**RESOLUTION HOLDING HEARING REGARDING REQUEST FROM EASTGATE PLAZA, LLC (OWNER), REPRESENTED BY NORMAN S. WEINSTEIN, FOR REVIEW AND APPROVAL OF AN 8TH AMENDMENT TO EASTGATE PLAZA PUD CONCEPTUAL PLAN, ON PROPERTY LOCATED AT 1514 EAST EUCLID AVENUE, TO ALLOW A CAR WASH USE**

Communication from the City Plan and Zoning Commission advising that at their December 1, 2022 meeting, the following action was taken regarding a request from Eastgate Plaza, LLC (owner), represented by Norman S. Weinstein (officer), for review and approval of an 8th amendment to the Eastgate Plaza PUD Conceptual Plan on the property located at 1514 East Euclid Avenue, to allow a car wash use.

**CITY OF DES MOINES, IOWA  
 EASTGATE PLAZA PUD CONCEPTUAL PLAN  
 - 8TH AMENDMENT  
 PREPARED BY VJ ENGINEERING  
 NOVEMBER, 2022**

CAR WASH PRELIMINARY SITE LAYOUT  
 1514 EAST EUCLID AVENUE  
 DES MOINES, POLK COUNTY, IA  
 PUD CONCEPTUAL PLAN

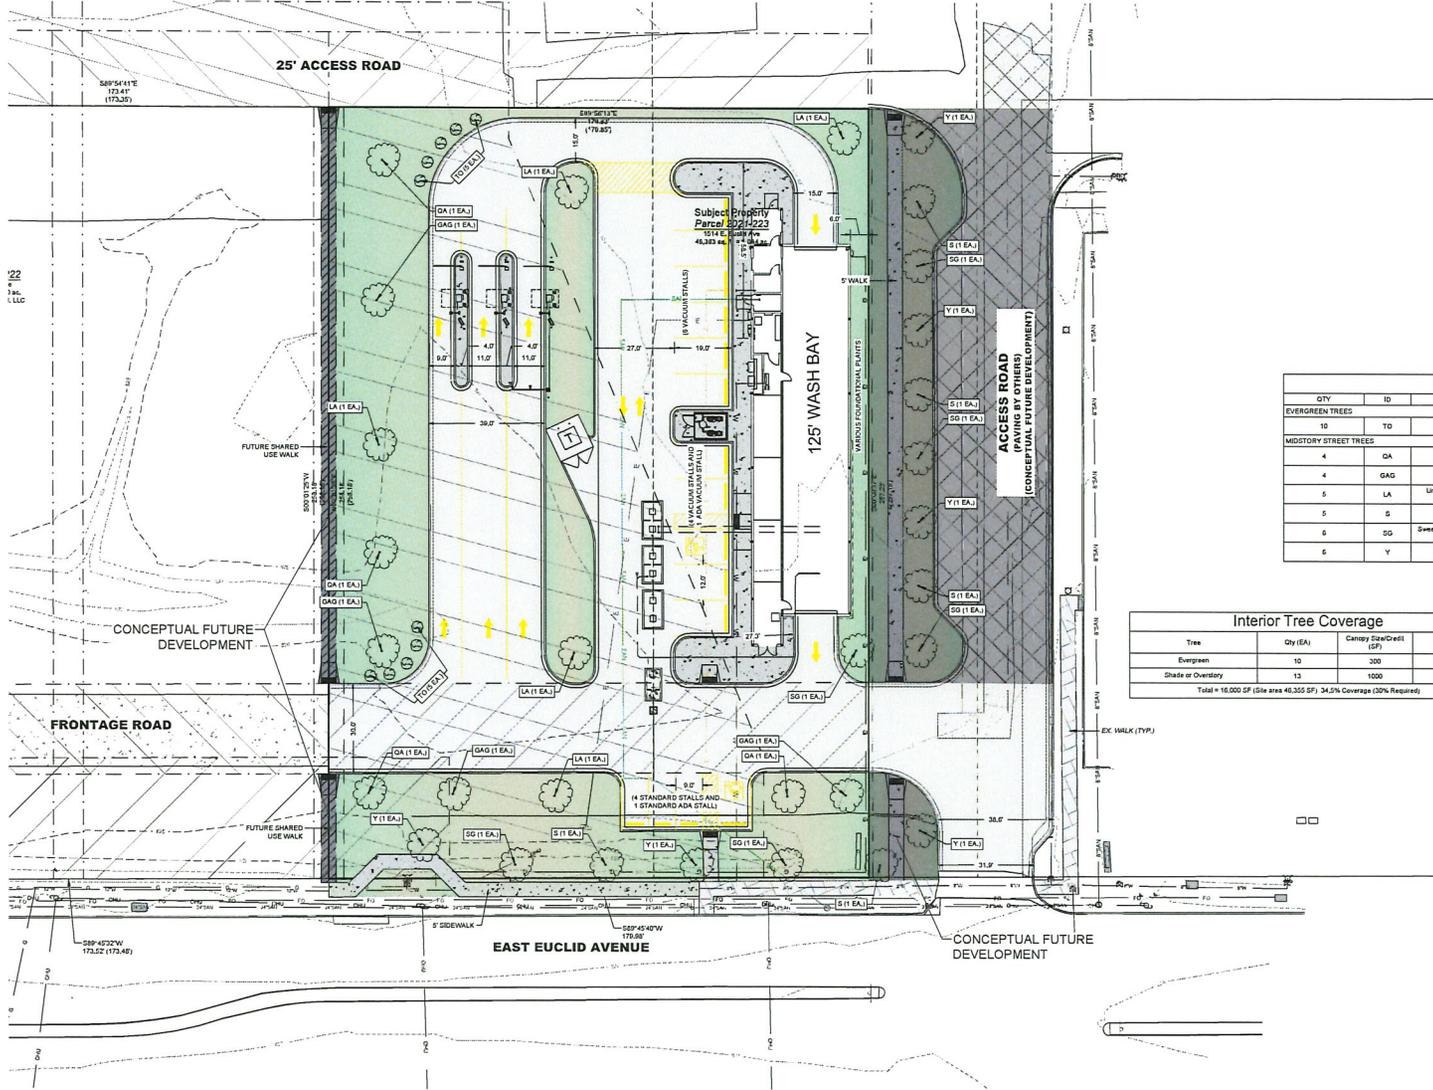
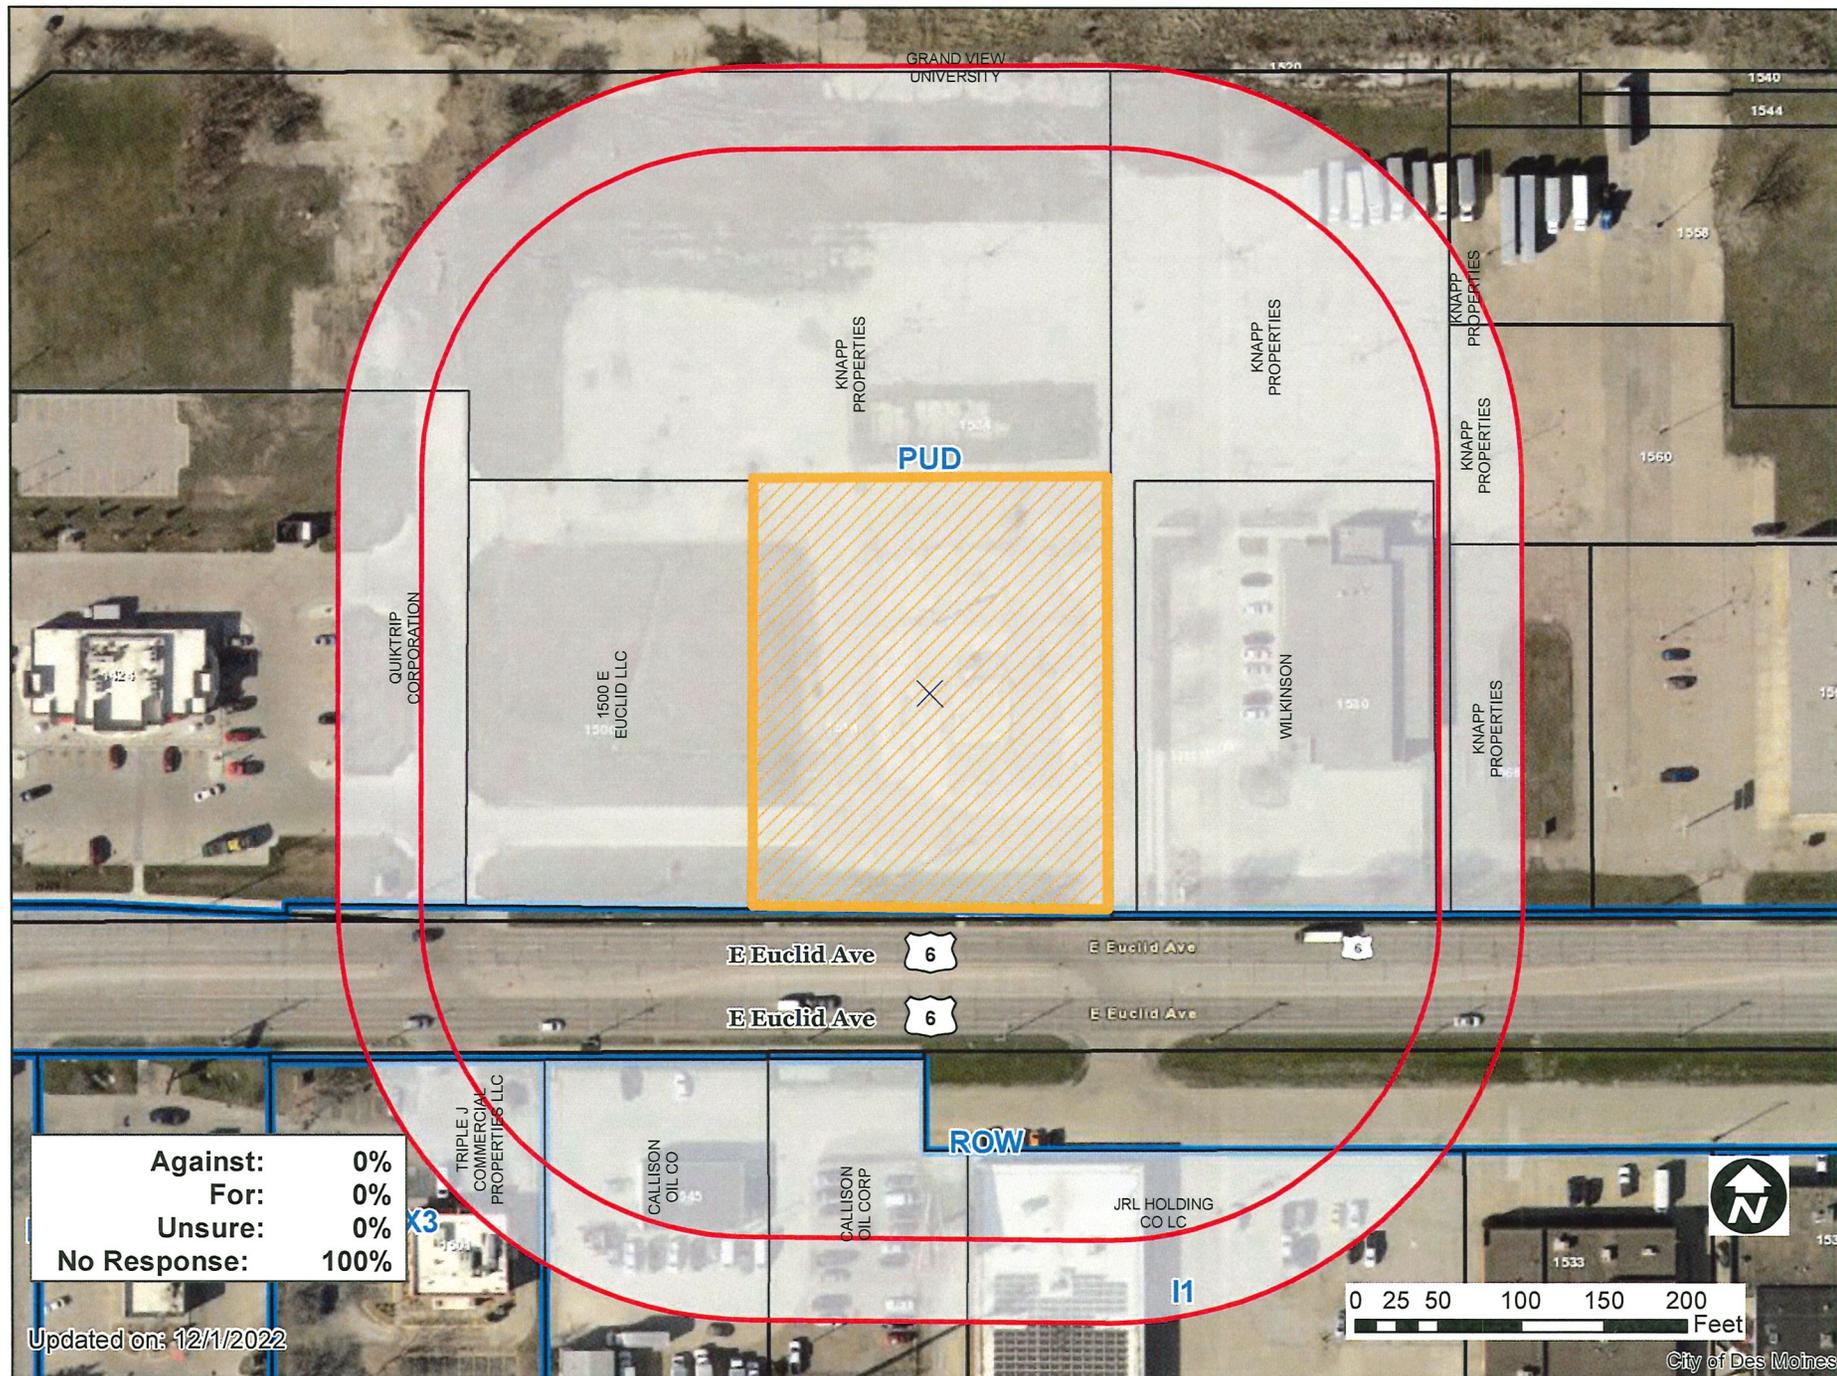
1. A note documenting any final design of the required “street-like” appearance of the 60-foot north/south drive easement shall occur at the time the adjacent property to the north is developed.
2. A note outlining time frame and responsibility of the north/south drive along the easterly line of the subject property, as determined, to the satisfaction of the Planning and Urban Design Administrator.

3. Any future construction or development of the site must comply with all applicable site plan and design regulations of the Planning and Design Ordinance (Chapter 135 of City Code).
4. Foundation plantings shall be provided along the east facade of the building in addition to site plantings in accordance with Chapter 135, Article 7 (Planning and Design Ordinance), of the City Code, as required in the "MX3" District, and shall be reviewed and approved by the City's Planning and Urban Design Division.

Staff recommends approval of the request, subject to provision of the following information in the General Notes section on the Eastgate Plaza PUD Conceptual Plan:

1. A note documenting any final design of the required "street-like" appearance of the 60-foot north/south drive easement shall occur at the time the adjacent property to the north is developed.

2. A note outlining time frame and responsibility of the north/south drive along the easterly line of the subject property, as determined, to the satisfaction of the Planning and Urban Design Administrator.

3. Any future construction or development of the site must comply with all applicable site plan and design regulations of the Planning and Design Ordinance (Chapter 135 of City Code).

4. Foundation plantings shall be provided along the east facade of the building in addition to site plantings in accordance with Chapter 135, Article 7 (Planning and Design Ordinance), of the City Code, as required in the "MX3" District, and shall be reviewed and approved by the City's Planning and Urban Design Division.

7. **Urban Design:** The proposed development would consist of a car wash building oriented north/south on the subject site with the short façade of the building facing East Euclid Avenue and the long façade of the building with a 10-foot setback from the east property line, a paved surface parking lot, and three paved pay lanes. The submitted elevations demonstrate building materials would consist of concrete masonry unit blocks and EIFS. The proposed elevations provide sufficient transparency (windows) on the east building façade, per agreement with staff.
